Technical Service Bulletin (TSB)
Global Telematics Box Module (TBM) Firmware Over The Air (FOTA) Update From R5N to R5T Software Level

REFERENCE:	TSB: 08-339-25 GROUP: 08 - Electrical	Date:	October 9, 2025	REVISION:	—
VEHICLES AFFECTED:	2025 - 2026 (DT) RAM 1500 Pickup This bulletin applies to vehicles equipped with Global Telematics Box Module (TBM) (Sales Code RDG).			MARKET APPLICABILITY: <input checked="" type="checkbox"/> NA <input type="checkbox"/> MEA <input type="checkbox"/> SA <input type="checkbox"/> IAP <input type="checkbox"/> EE <input type="checkbox"/> CH NOTE: This bulletin applies to the North America market.	
CUSTOMER SYMPTOM:	The customer may comment on the following: <ul style="list-style-type: none"> Radio screen displays "Uconnect Box Error" with the message "Uconnect Box requires service. Please visit an authorized dealer" Fig. 1. Rear View Camera (RVC) functions normally. 				
CAUSE:	Issue With Antenna Startup Time

**Fig. 2**

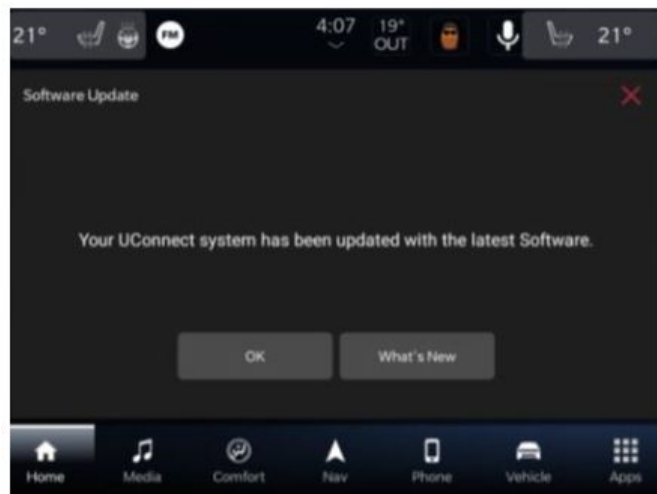
1. The vehicle needs to be in 'Park'. The ignition needs to be in the off position.
2. If the customer selects “Update Now” [Fig. 3](#) they can shut off the vehicle and leave. The update will be completed automatically.
